Models Affected: DN5800-3 & 4, DN3800-3 & 4

Product Notice

Subject: Fluorescent Ballasts in BevMAX Machines

Supplemental Information Sheet

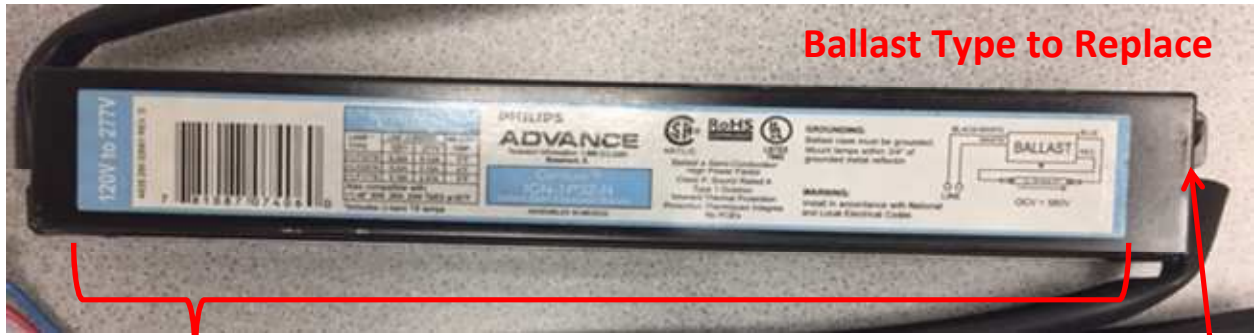
The fluorescent light ballasts will be located within the service compartment on the left-hand monetary wall facing the machine.

1. Before initiating any service, switch off power to the machine or unplug the power cord before proceeding with this service replacement activity.
2. With the power off to the machine, disconnect the wire harnesses of each of the ballast assemblies from the harness connection going to the AC power distribution box and the harness connection going to the individual lamp assemblies.

3. With the harnesses disconnected, you can now remove the ICN ballast assemblies from the service area by removing the screws and lifting the ballast from the slot in the monetary wall.

5. Replace the ICN ballast assemblies with the new Type CC ballast using the same screws removed from the existing assemblies.
6. Reconnect all harness connections, check all connections to ensure they are secure. Ensure all lamps are seated securely in the lamp holders.

Ballast Type to Replace

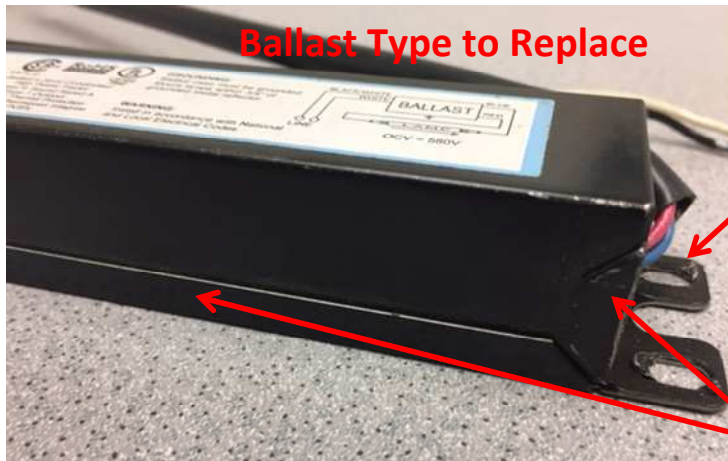
ICN ballasts with these identifying features **MUST** be removed and replaced:

Distinguishing features:

Full length label

Date code appears stamped on rear of metal case
